Site Audit Report

No Scrape Area, North of Swale, Former Schofields Aerodrome, off
Mariners Avenue, Schofields

Audit Number: MP169_02_R

25 June 2021

Figure 4: Borehole locations (March 2021) and approximate cut/fill ranges (Ramboll, 2017)

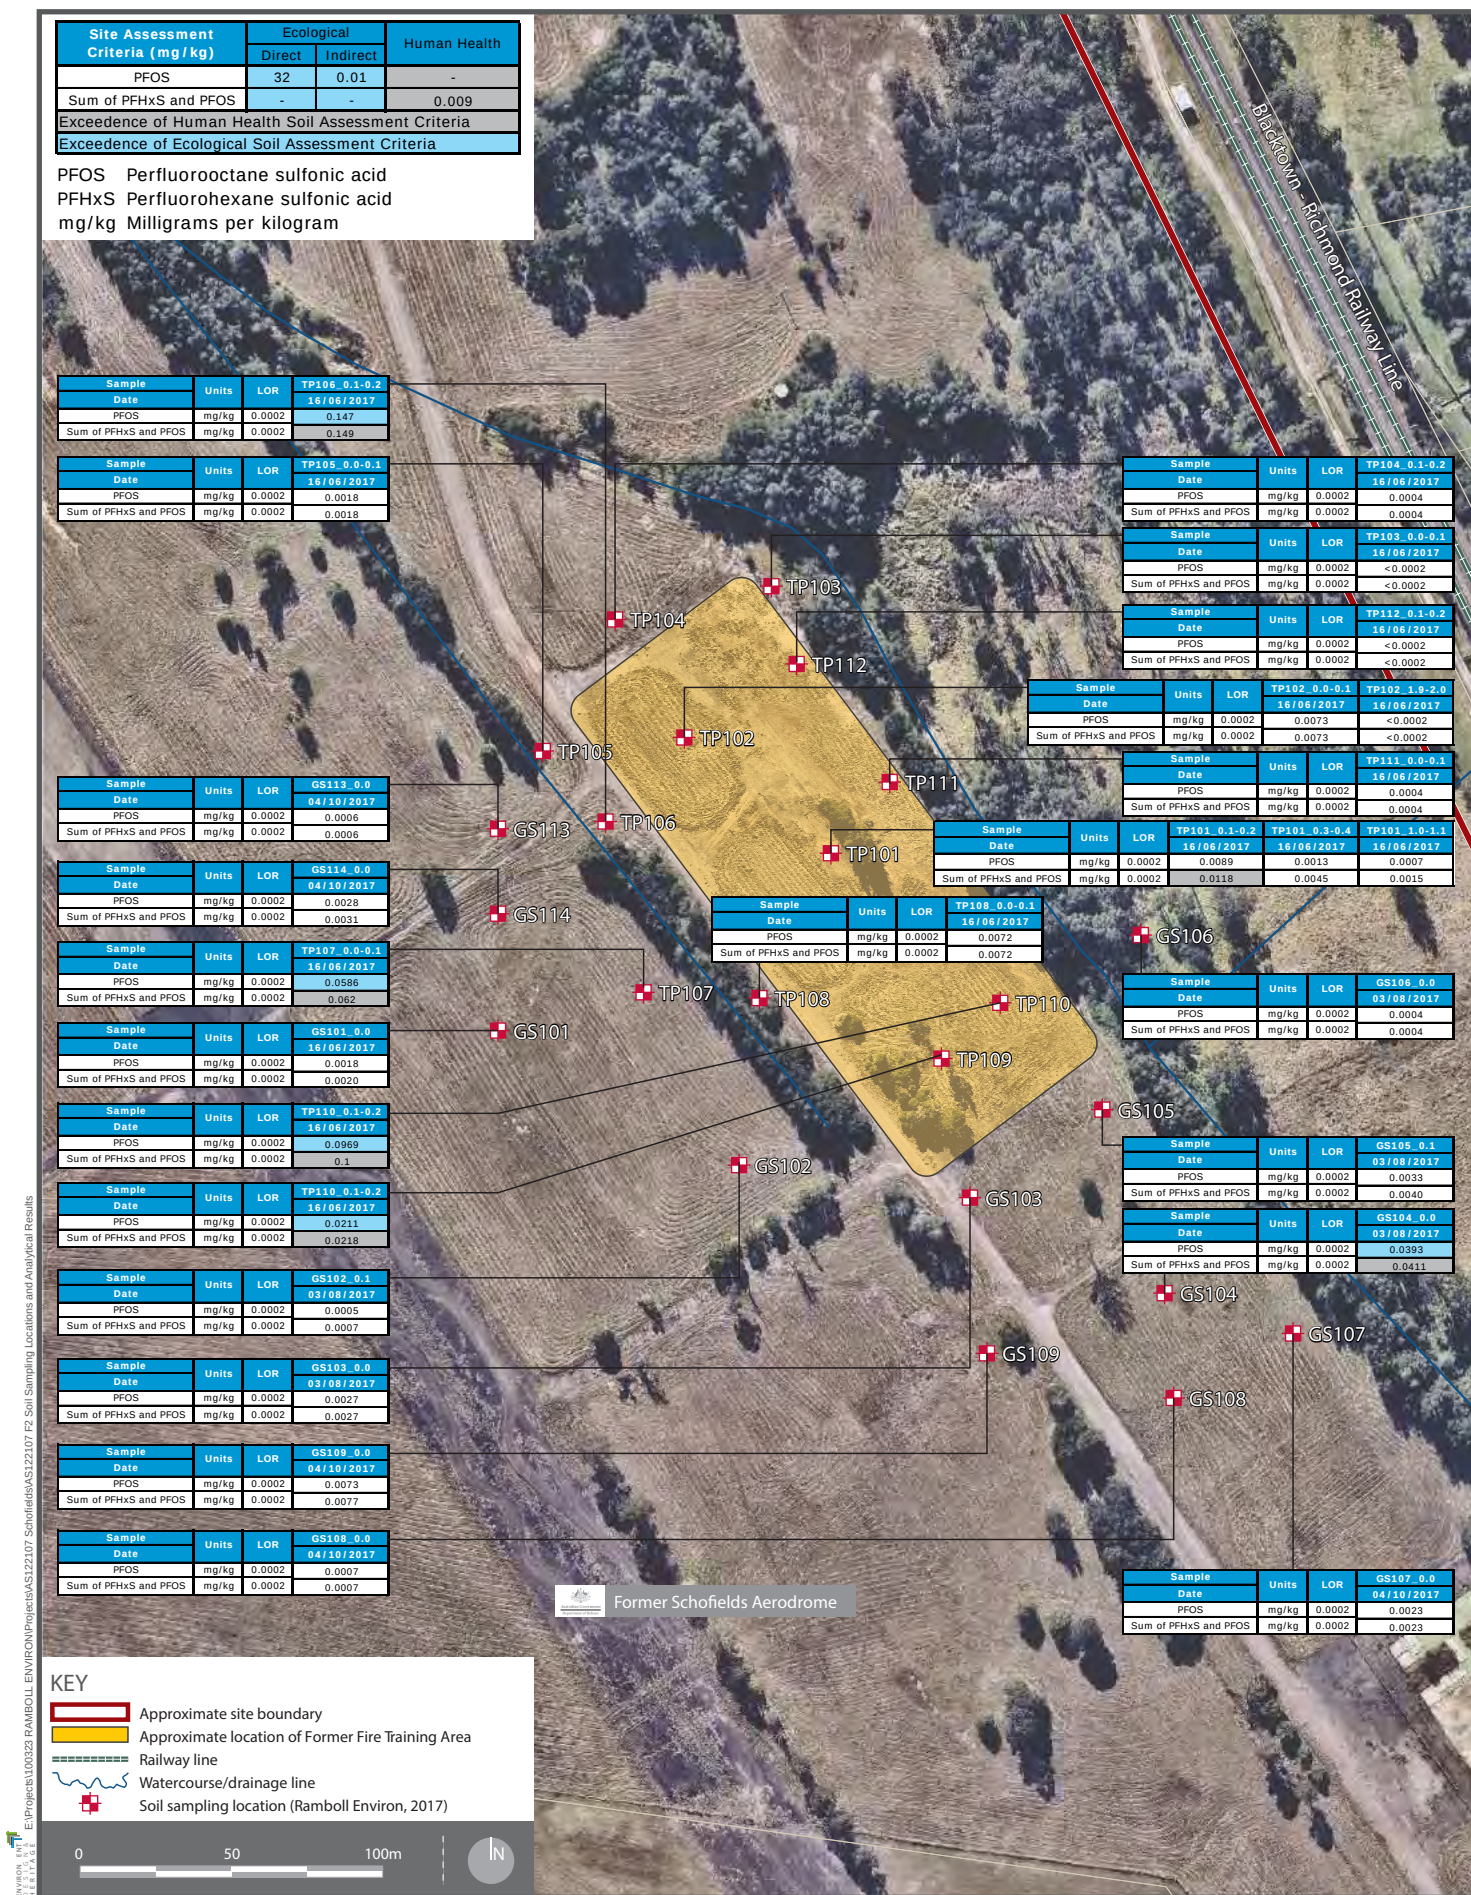
The earthworks contractor for the Nirimba Field development prepared a cut and fill plan dated 23 March 2021 for the audit site. This is provided as Figure 4 of the Validation Report (presented as Attachment 4, **Appendix A**) and this was used by Ramboll to design their intrusive validation field program. This indicated greater than 4 m of VENM was placed in western portion of the site (areas proposed for residential use) and that the thickness of VENM decreases towards the swale (eastern site boundary).

The VENM thickness observed at the validation soil bores are generally consistent with the cut and fill plan dated 23 March 2021 provided in Attachment 4 of **Appendix A**.
